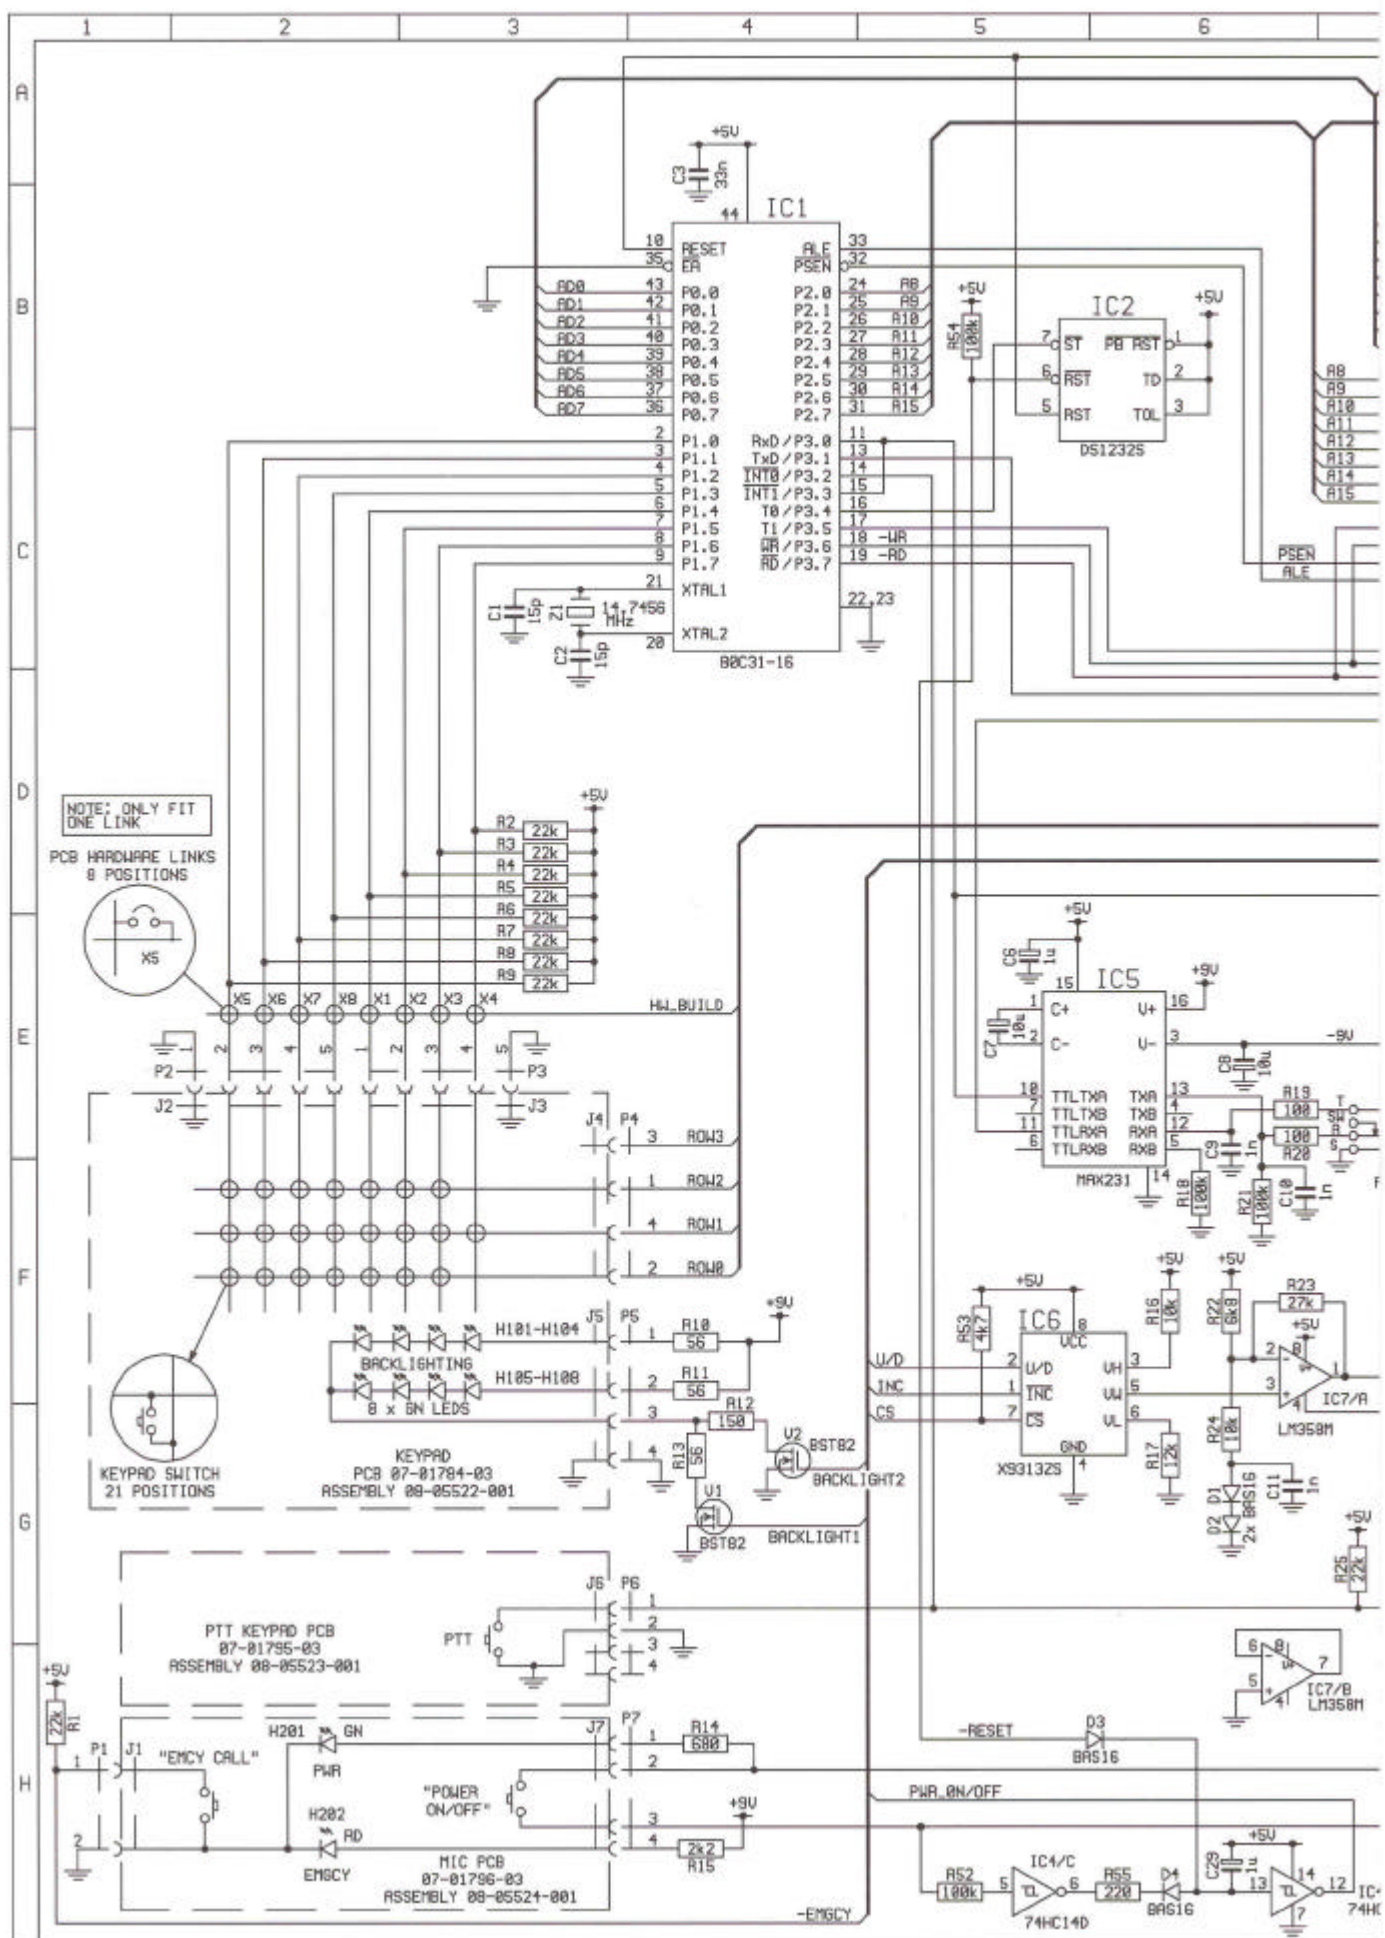
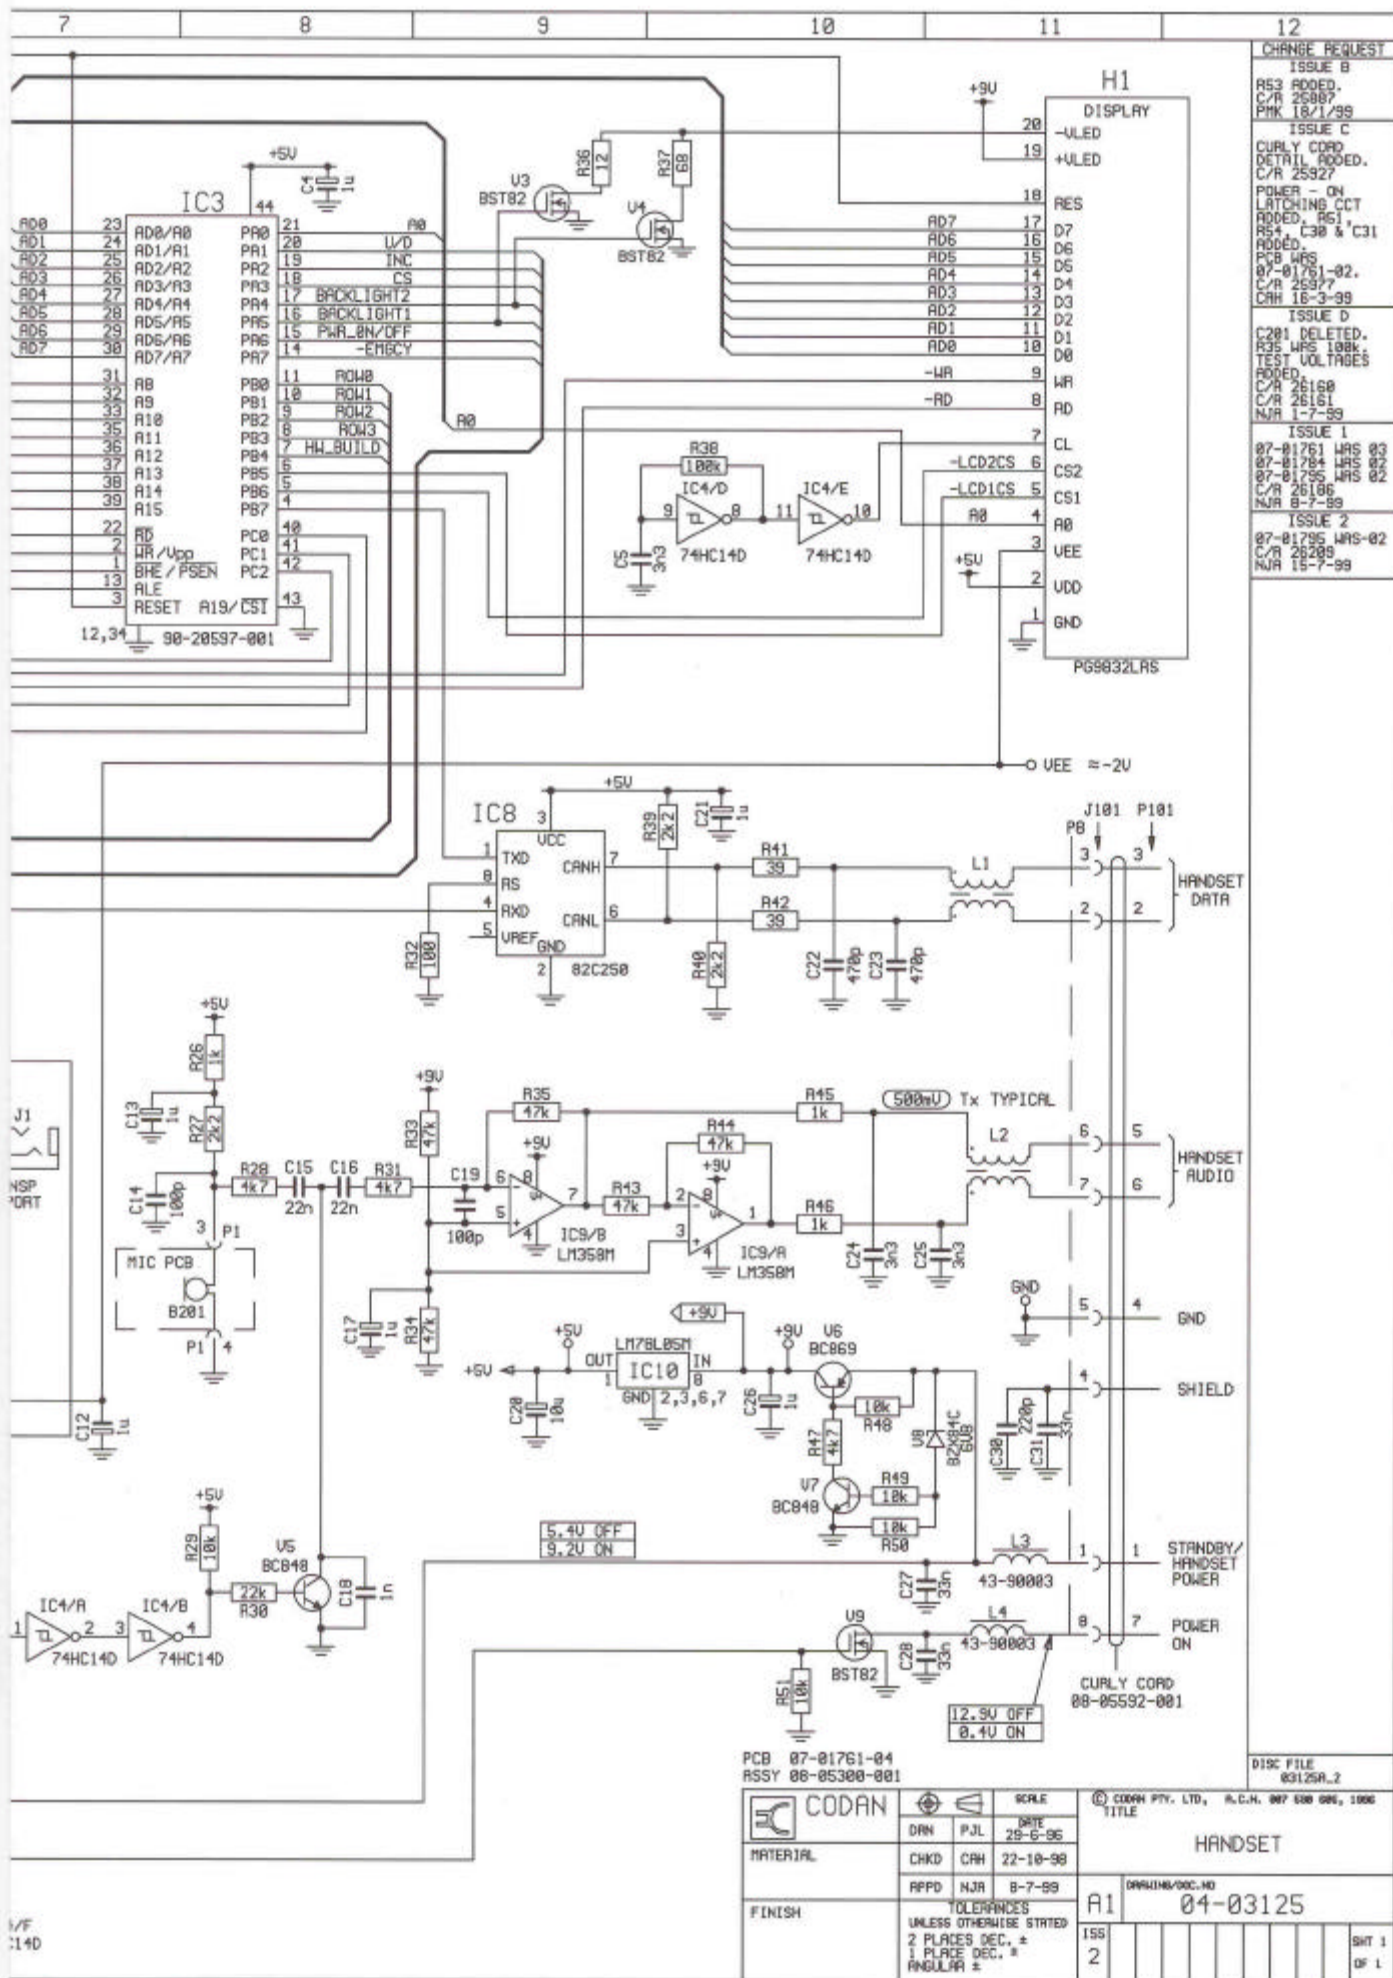
CHANGE REQUEST
ISSUE B
R53 ADDED. C/R 25887 PMK 18/1/99
ISSUE C
CURLY CORD DETAIL ADDED. C/R 25927
POWER - ON LATCHING CCT ADDED. R51 R54, C30 & C31 ADDED. PCB WAS 07-01761-02. C/R 25977 CAH 18-3-99
ISSUE D
C201 DELETED. R35 WAS 100k TEST VOLTAGES ADDED. C/R 26160 C/R 26161 NJR 1-7-99
ISSUE 1
07-01761 WAS 03 07-01764 WAS 02 07-01795 WAS 02 C/R 26186 NJR 8-7-99
ISSUE 2
07-01795 WAS 02 C/R 26209 NJR 15-7-99
